**RE: National Construction Code (NCC) 2022 Volume One Section J
Part J4 Building Fabric Statement of Compliance**

JOB NO.: 230339

REV. NO.: REV A

SUBJECT PREMISE: Castlecove Redevelopment (Clubhouse) | 68 Deepwater Road, Castle Cove NSW 2069

DA 3.09

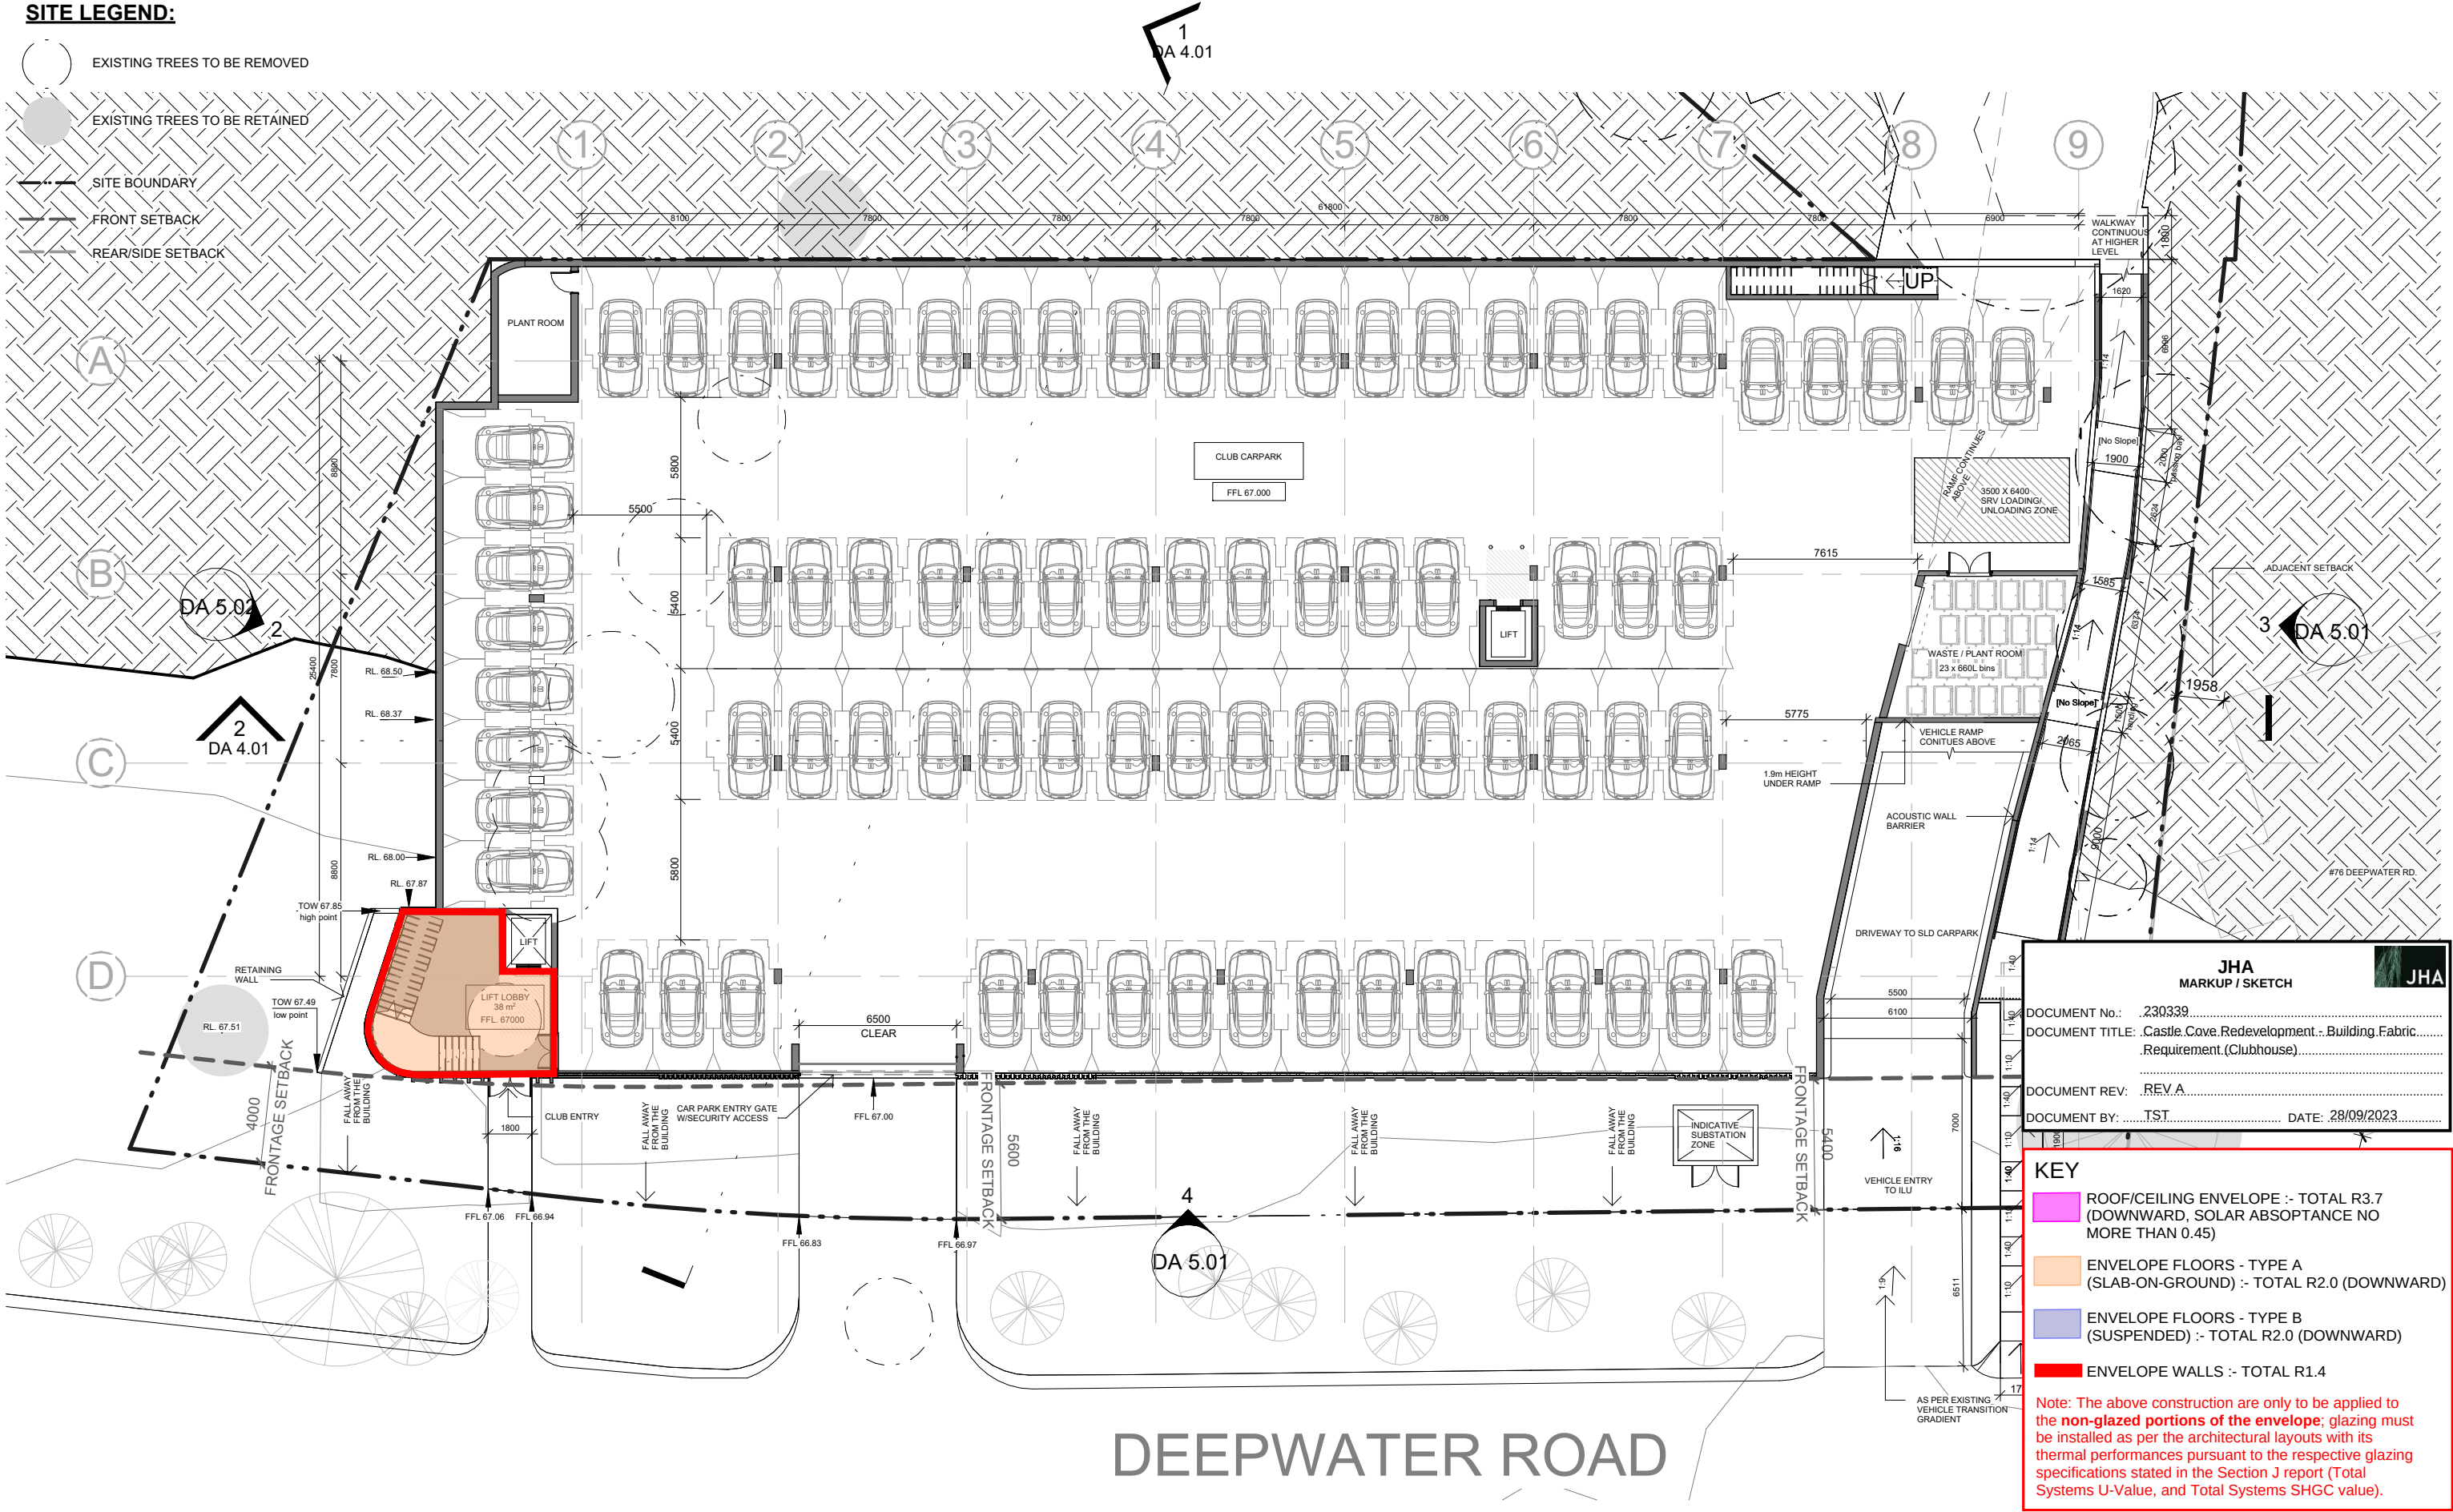
JHA
MARKUP / SKETCH

- ROOF/CEILING ENVELOPE :- TOTAL R3.7 (DOWNWARD, SOLAR ABSOPTANCE NO MORE THAN 0.45)
- ENVELOPE FLOORS - TYPE A (SLAB-ON-GROUND) :- TOTAL R2.0 (DOWNWARD)
- ENVELOPE FLOORS - TYPE B (SUSPENDED) :- TOTAL R2.0 (DOWNWARD)
- ENVELOPE WALLS :- TOTAL R1.4

Note: The above construction are only to be applied to the non-glazed portions of the envelope; glazing must be installed as per the architectural layouts with its thermal performances pursuant to the respective glazing specifications stated in the Section J report (Total Systems U-Value, and Total Systems SHGC value).

DRAWING NO.
DA 3.11

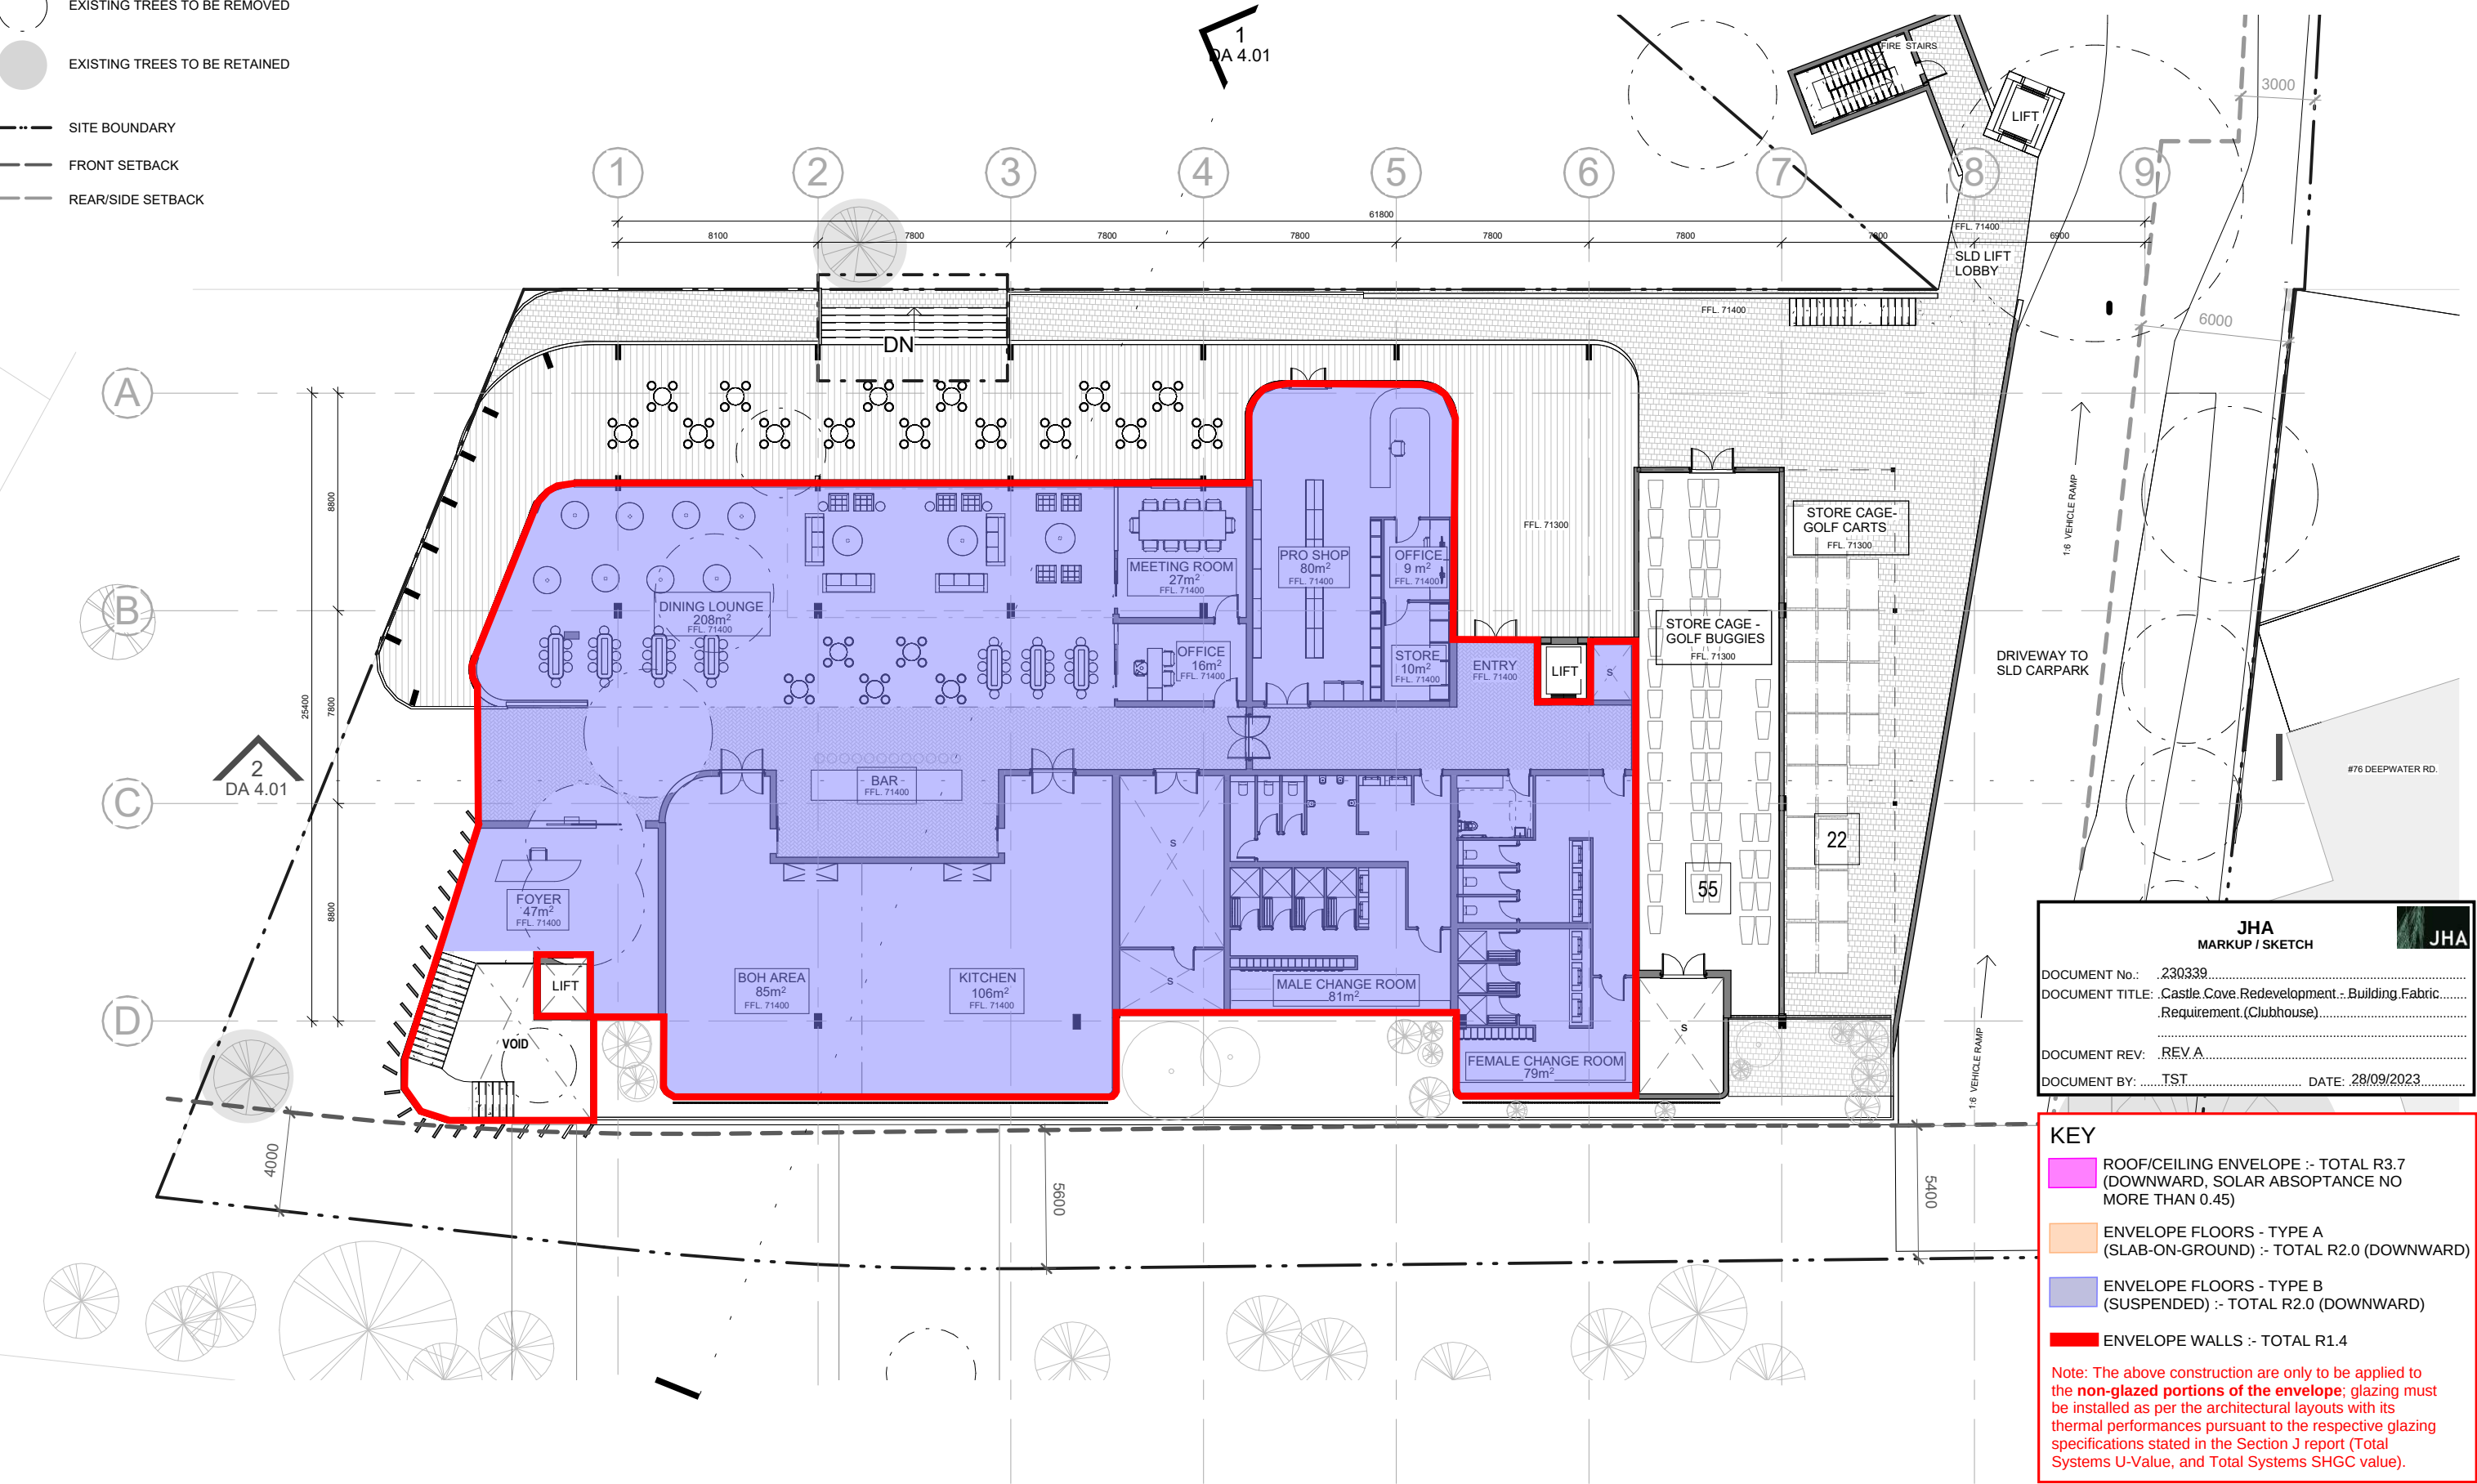
JHA
MARKUP / SKETCH

ROOF/CEILING ENVELOPE :- TOTAL R3.7 (DOWNWARD, SOLAR ABSOPTANCE NO MORE THAN 0.45)

ENVELOPE FLOORS - TYPE A (SLAB-ON-GROUND) :- TOTAL R2.0 (DOWNWARD)

ENVELOPE FLOORS - TYPE B (SUSPENDED) :- TOTAL R2.0 (DOWNWARD)

ENVELOPE WALLS :- TOTAL R1.4

Note: The above construction are only to be applied to the non-glazed portions of the envelope; glazing must be installed as per the architectural layouts with its thermal performances pursuant to the respective glazing specifications stated in the Section J report (Total Systems U-Value, and Total Systems SHGC value).
